**MONTGOMERY COUNTY HISTORIC PRESERVATION COMMISSION**  
**STAFF REPORT**

<b>Address:</b>	7204 Maple Avenue, Takoma Park	<b>Meeting Date:</b>	9/4/2024
<b>Resource:</b>	Contributing Resource <b>Takoma Park Historic District</b>	<b>Report Date:</b>	8/28/2024
<b>Applicant:</b>	Paul Schwengels (James Simeone, Project Coordinator)	<b>Public Notice:</b>	8/21/2024
<b>Review:</b>	HAWP	<b>Tax Credit:</b>	Yes
<b>Permit No.:</b>	1077124	<b>Staff:</b>	Dan Bruechert
<b>Proposal:</b>	Fenestration and Siding Alterations

To: Montgomery County Planning  
Takoma Park Historic Review Board

Please note that the following corrections have been made to the re-submitted permit drawings for the above referenced address. These corrections should reflect MW Architects LLC response to your comments.

SCALE:	1/4" = 1'-0"
SHEET TITLE:	EXISTING ELEVATIONS
SHEET NUMBER:	A2.0

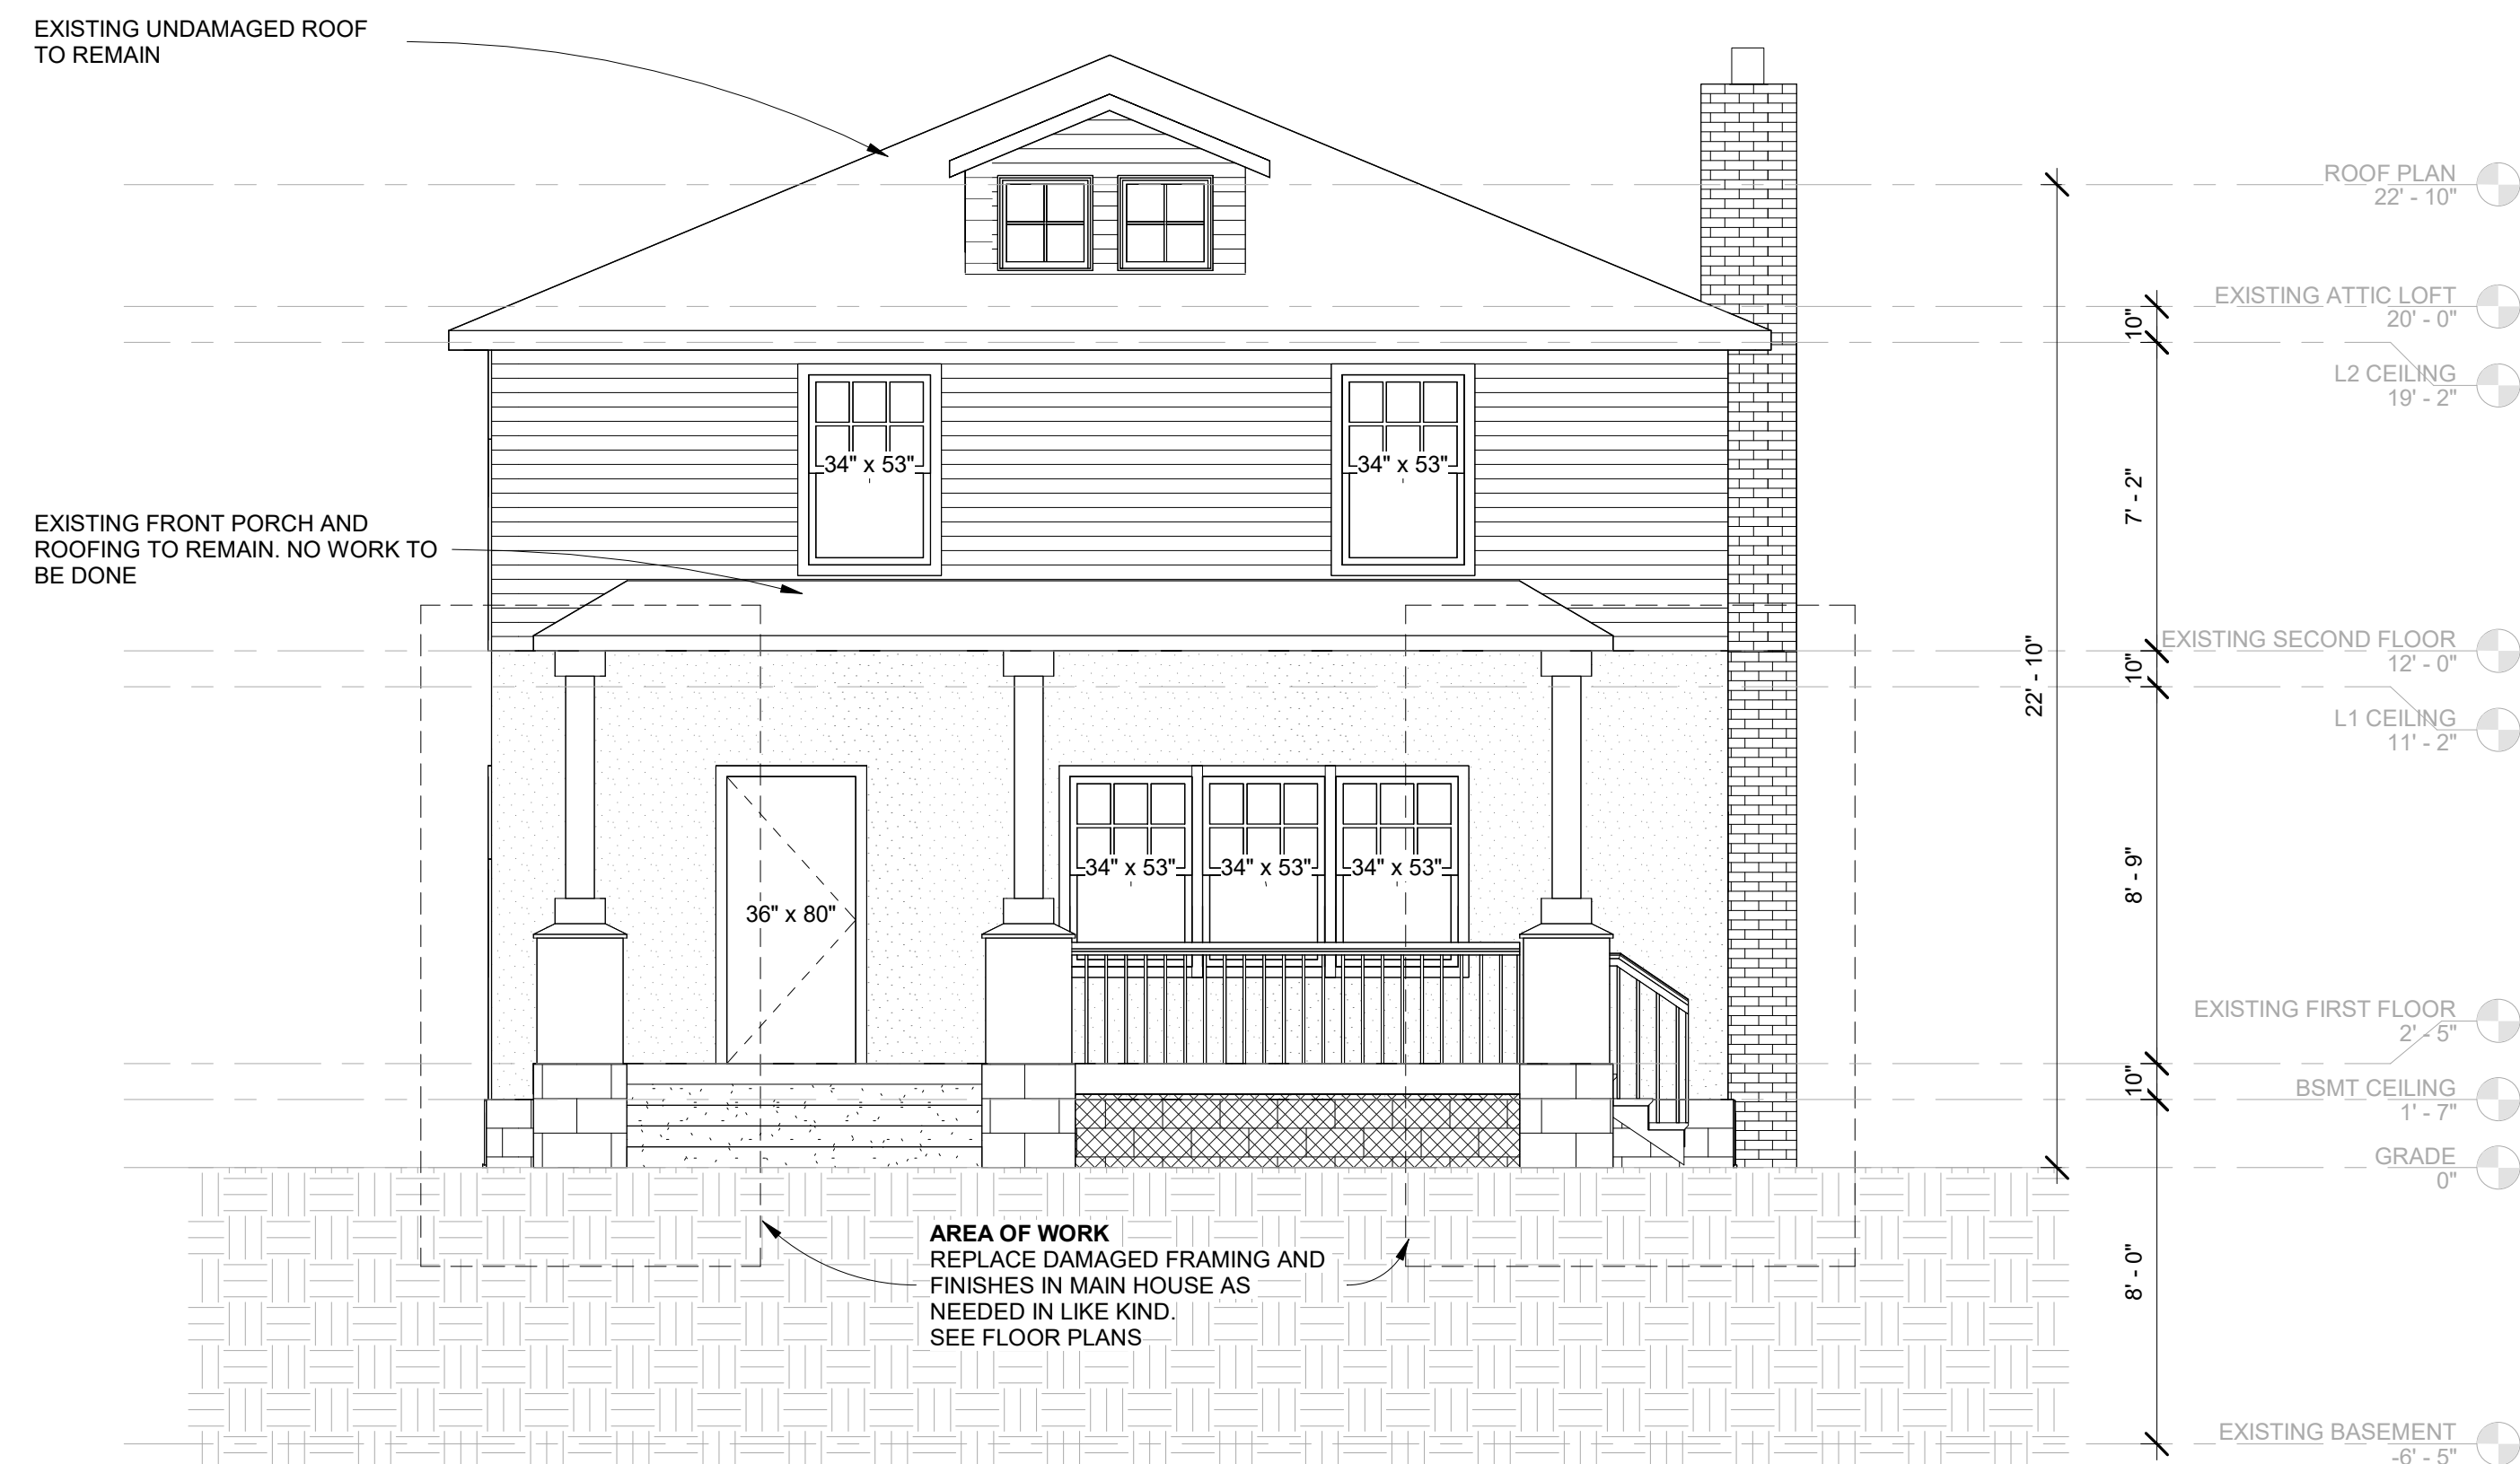
**6. Incomplete drawings.** “Elevations of all four sides of the house need to be provided with the application. In some cases, we can get away with a single elevation. But the work proposed is on all elevation. Please provide elevations of all four sides of the houses.”

*a. Please see sheet A2.0 and A2.1 for existing & proposed elevations.*

5 Deck Railing  
3/4" = 1'-0"

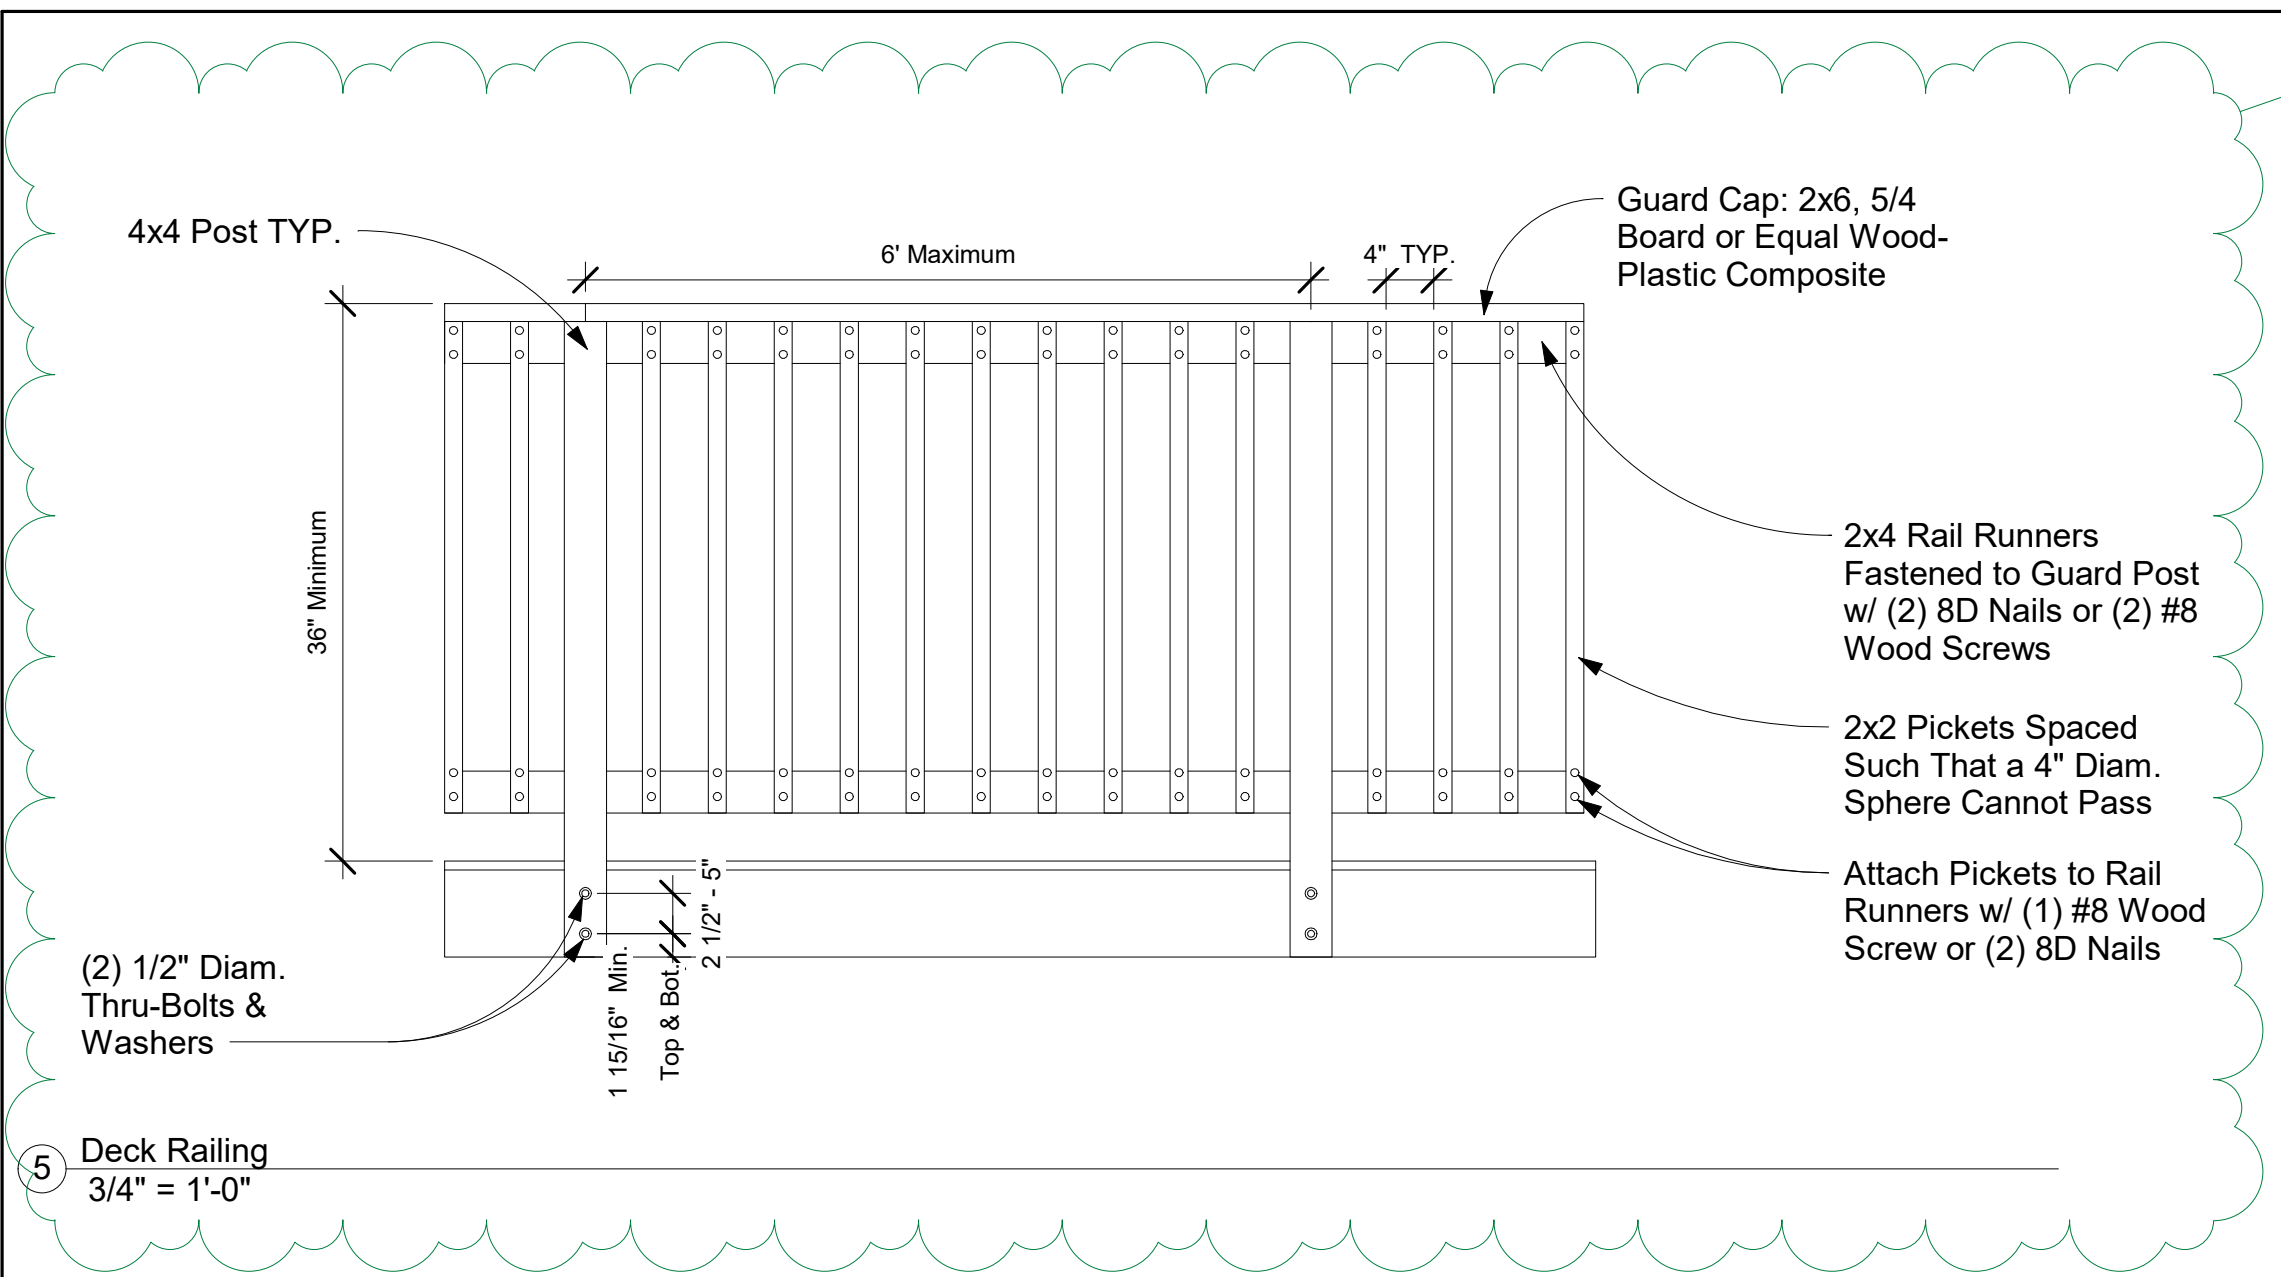
- a. *No work to be done on the rear exterior stairs of the house.*
3. **Balcony off master bedroom.** “The detail of the elevation drawings doesn’t indicate the railing detail and whether the existing bracing will be retained. Please provide a railing detail for the deck and indicate whether any additional framing not under the balcony surface is required.”

- a. *Noted. Please see detail 5/S1.1 for the railing detail. The existing bracing is not needed and can be removed once damaged framing has been replaced in like kind.*
